**BEFORE THE OFFICE OF ENERGY INFRASTRUCTURE SAFETY
OF THE STATE OF CALIFORNIA**

**COMMENTS OF THE GREEN POWER INSTITUTE ON THE DRAFT
DECISION ON PG&E'S 2025 WILDFIRE MITIGATION PLAN UPDATE**

September 18, 2024

Figure 1. Reproduction from PG&E data request response “Data Request OEIS_016-Q003 Supplemental Response 001, Attachment 01”

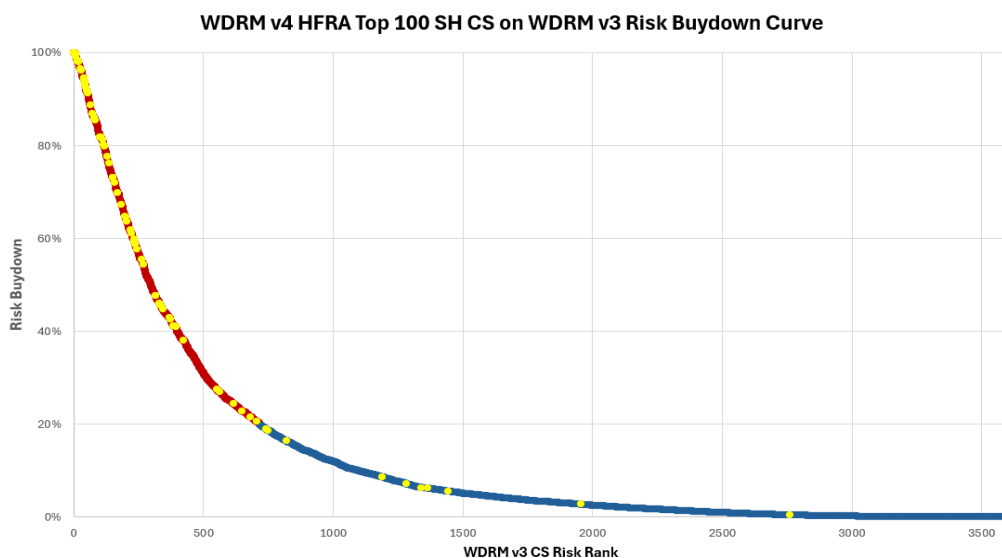
First, the Draft Decision attempts to explain the relationship between the "top 100 riskiest circuit segments", the "top 20 percent of risk," and the "top 20 percent" for WDRM V3 and V4. We infer that the "top 20 percent" means the "top 20 percent of risk-ranked circuit segments." The data summary is flawed. In the cited Data Request response PG&E provided two figures

comparing WDRM V3 and V4 Risk Buydown versus Risk Rank.¹¹ Figure 1, reproduced from Data Request OEIS_016-Q003 Supplemental Response 001, Attachment 01, presents percent “Risk Buydown” on the y-axis, which maxes out at 100 percent (i.e. total system wildfire risk). Risk Buydown values refer to residual or remaining percent of total risk on the system. This is in contrast to the data in red, which are originally referred to as the “top 20 percent of circuit segments” for each WDRM version in an earlier discovery response.¹² The issues lie in the fact that the “top 20 percent of risk” and the “top 20 percent of [risk-ranked] circuit segments” are not interchangeable terms. As previously reported the top 20 percent of risk ranked circuit segments totals 720 circuit segments.¹³

The specific circuit segments that comprise the top 720 risk-ranked circuit segments and the percent total risk, risk distribution, and mileage, change to varying degrees with each model version. This is apparent in the WDRM V3 and V4 comparison figures, where the percent of system risk associated with the “top 20 percent” of risk-ranked circuit segments in red decreases

from approximately 80 percent to 60 percent.¹⁴ The Draft Decision statement that the majority of the 100 top CS fall within the “top 20 percent of risk” is incorrect since the top 20 percent of risk is contained in circuit segments that span the 100 to 80 percent risk buydown portion of Figure 1. The statement is further confounded by asserting that just 10 of the 100 top WDRM V4 circuit segments fall outside the WDRM V3 “top 20 percent,” presumably referring to the risk-ranked circuit segments denoted by red data points (Figure 1). Based on Figure 1, 10 of the WDRM V4 top 100 SH circuit segments (CS) fall outside the *top 80 percent of risk* based on WDRM V3 and outside the top 20 percent of risk-ranked circuit segments. Consequently, the correct finding is that the majority of the WDRM V4 HFRA top 100 SH circuit segments fall outside the WDRM V3 top “20 percent of risk” according to the risk buydown curve (Figure 1).

The Draft Decision should be modified to correct these factual and technical errors. GPI recommends the following corrections to the Draft Decision (additions in blue underline, deletions in red strikethrough):

As a result of these significant risk model updates, PG&E's wildfire mitigation prioritization has changed. The number of circuit segments comprising the top 5 percent of total utility risk decreased from 49 circuits to 14 circuits. PG&E stated that the decrease is due to a flattening of the risk buydown curve, with a more even distribution of risk across the system when compared to WDRM V3. When comparing the top 100 riskiest circuit segments in the WDRM V4 output to the WDRM V3 output, the majority of the circuit segments ~~still fall outside in~~ the top 20 percent of risk ~~according to between~~ WDRM V3 ~~and WDRM V4, with only 10~~ Ten of the top 100 riskiest circuit segments in the WDRM V4 output fall ~~circuit segments within the top 20 percent for~~ ~~WDRM V4 falling~~ outside of the top ~~20~~ 80 percent of risk in WDRM V3. ~~This indicates that the changes made by PG&E are improvements to the precision of its risk model. This suggests that the maturing WDRM risk model is still unstable. Additionally, while some movement occurred to the risk ranking based on model output changes, the~~ The changes in ~~prioritization~~ risk-rank that result from the risk model updates from WDRM V3 to WDRM V4 do not have as much movement as the previous relative rank changes ~~in prioritization~~ when PG&E implemented a new model version. This indicates that PG&E's modeling may be progressing ~~advancing towards stabilization.~~ However, this remains uncertain since we expect additional substantive model revisions such as the inclusion of an outage to ignition risk analysis. ~~to the point that its updates are more refinements to previous model versions instead of significant changes, which should be indicative of PG&E having a better understanding of the risk on its system.~~²⁰
